RE: Pine Bend Landfill Vertical Expansion Project

**IN THE MATTER OF THE DECISION
ON THE NEED FOR AN ENVIRONMENTAL
IMPACT STATEMENT FOR THE PROPOSED
PINE BEND LANDFILL VERTICAL EXPANSION
INVER GROVE HEIGHTS, DAKOTA COUNTY, MINNESOTA**

**FINDINGS OF FACT
CONCLUSIONS OF LAW
AND ORDER**

**Re: City of Inver Grove Heights' Public Comments on Pine Bend Landfill's
2023 Environmental Assessment Worksheet (EAW) for Request for Major
Modification of Permit #SW-45**

Figure 1. 1916 plat map – 116.79 acre parcel owned by J. Chapron

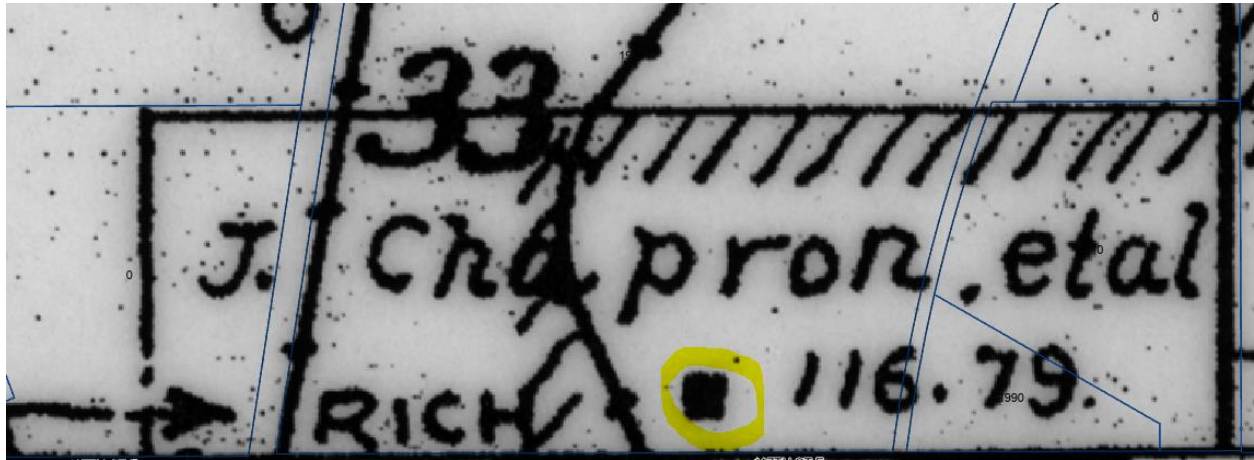
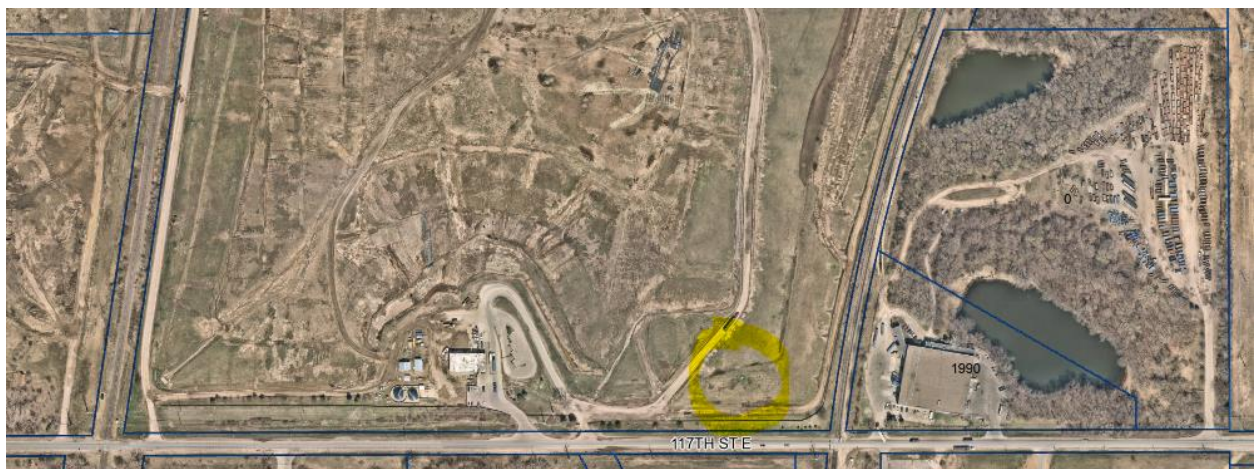
Habitation in SE quarter of Section 33 on Pine Bend Landfill at 2495 117th St E, Inver Grove Heights. Area of possible one or more unsealed domestic wells is circle in yellow in figures below.

Table 17: Operational Emissions

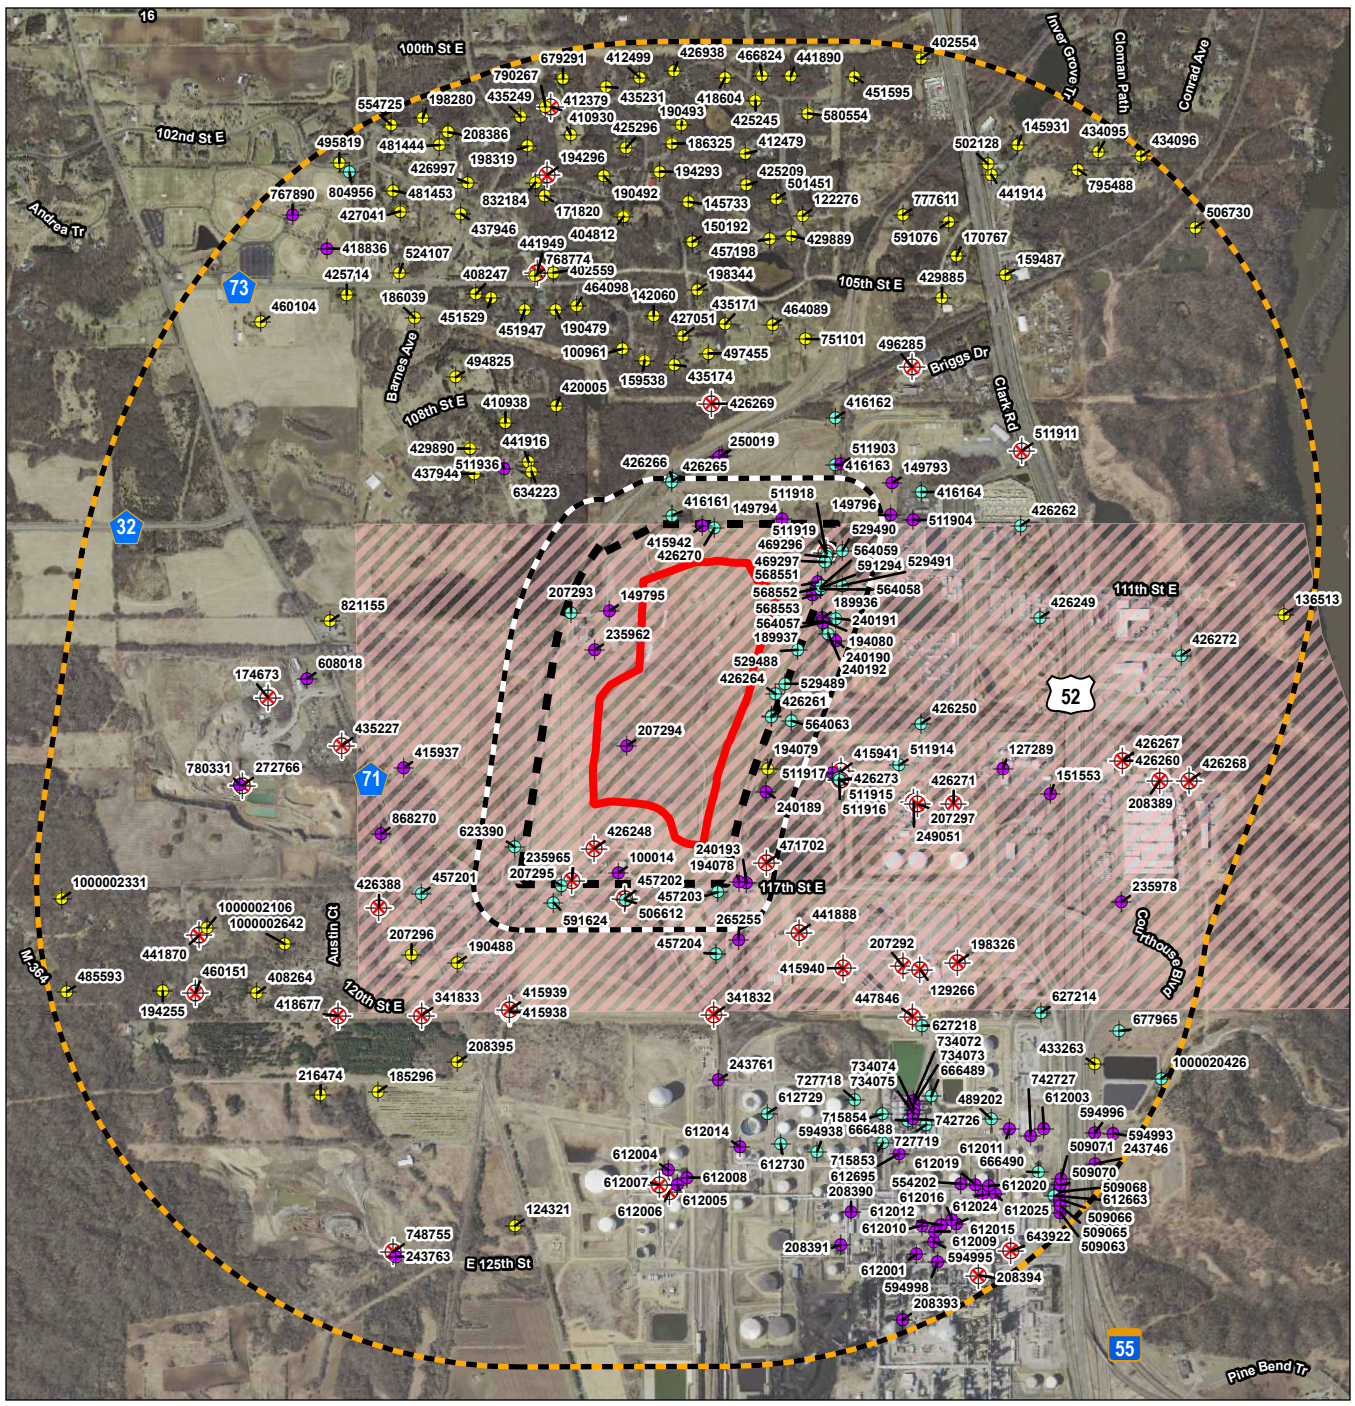
36. Pages 62 and 63, Greenhouse Gas (GHG) Emission/Carbon Footprint. The GHG emissions reported in Tables 16 and 17 of the EAW match those in Appendix A of the GHG Assessment Report (attached as Appendix H to the EAW).. Appendix A, in turn, references the calculations in Appendix B of the GHG Assessment Report. However, there appears to be several errors converting tons to Mtons in the supporting workbook. Specifically, we believe the CO₂e (Mtons/yr) reported in Appendix A for the “RNG Plant”, “Waste Disposal Operations” and “Insignificant Operations” are incorrect. The total emissions from all sources should be 6,872,268.85 rather than 6,250,729.31 Mton/yr. The suggested edits are included in the following table. Please correct or explain.
